UNITED STATES PATENT AND TRADEMARK OFFICE

Office Action Summary

10/718,397

LOFLAND ET AL.

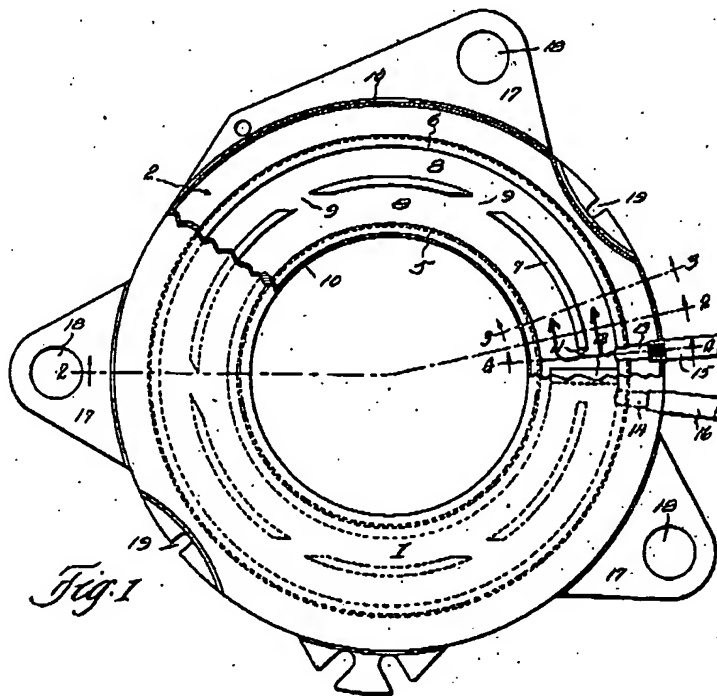
Claims 1 and 10 are rejected under 35 U.S.C. 102(b) as being clearly anticipated by Vandergrift. Vandergrift (Figure 2-5) discloses a first member 1 with semi-circular channel walls 3, 4 interlaced with a second member 2 with semi-circular channel walls 5, 6, 7 to provide two fluid flow paths having different directions (marked-up Figure 1 below).

The first fluid flow path from fluid inlet 13 turns immediately into the outer channel 8 proceeding until it turns immediately into the fluid outlet 14. The second fluid path extends radially inward or straight from the fluid inlet 13 and turn into the inner channel 8 beyond the semi-circular wall 7 proceeding until it turns immediately toward the fluid outlet beyond the semi-circular wall 7.

With respect to applicant's remarks in view of Vandergrift, the scope of the claim does not preclude the Examiner's reading of Vandergrift having "two fluid flow paths having different flow directions between the fluid inlet and fluid outlet." The claim does not recite the length of

the flow path or the relative directions of the flow paths. Therefore, the two fluid flow paths of Vandergrift, i.e. one flow path turning immediately into the outer channel from the fluid inlet 13 and the other flow path extending radially inward or straight from the fluid inlet and turning into the inner channel 8 are "different" flow directions "between the fluid inlet and fluid outlet." The Examiner agrees Vandergrift does not disclose opposite clockwise and counterclockwise directions, which is not recited in the claims.
